## Access Compliance Report Public Rights-of-Way (Curb Ramps)

Intersection ID: 31207 Main Street: OAKTON\_HUNT\_DR Cross Street: GOODLOE\_DR Location: N

ADA ID: FE174FF0AE75 Ramp Type: PerpDiag Initial Pass/Fail: Fail Overall Compliance: No Severity Score: 8.75

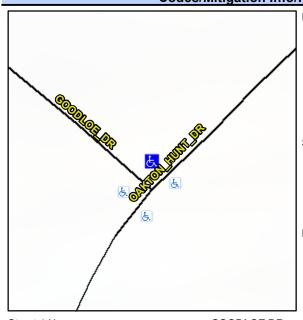
Not Found, R304.5.1

Field Measurements/Component Compliance					
Compliance Description		Data	Compliance Description		Data
N/A	Ramp Length (in)	48.0	Yes	Ramp Slope (%)	6.2
No	Ramp Width (in)	46.0	Yes	Ramp XSlope (%)	1.0
N/A	Flare Type LT	N/A	N/A	Flare Type RT	N/A
N/A	Flare Slope LT (%)	N/A	N/A	Flare Slope RT (%)	N/A
N/A	Flare Traversable LT?	N/A	N/A	Flare Traversable RT?	N/A
N/A	Landing Length (in)	N/A	N/A	DWS Provided?	N/A
N/A	Landing Width (in)	N/A	N/A	DWS Contrast?	N/A
N/A	Landing Slope (%)	N/A	N/A	DWS Length (in)	N/A
N/A	Landing X Slope (%)	N/A	N/A	DWS Full Width?	N/A
N/A	Landing Curb? (Y/N)	N/A	N/A	DWS Offset (in)	N/A
N/A	Shared Landing?	N/A			
N/A	Gutter Ponding?	N/A	N/A	Gutter Slope (%)	N/A
N/A	Gutter Lip Ht (in)	N/A	N/A	Gutter X Slope (%)	N/A
N/A	Painted X Walk1?	No	N/A	Painted X Walk2?	No
	X Walk 1 Direction	To SW		X Walk 2 Direction	To SE
N/A	X Walk 1 Width (in)	N/A	N/A	X Walk 2 Width (in)	N/A
	X Walk 1 Slope (%)	5.3		X Walk 2 Slope (%)	3.3

Remove & Replace Curb Ramp With Two New Directional Ramps or Equivalent.
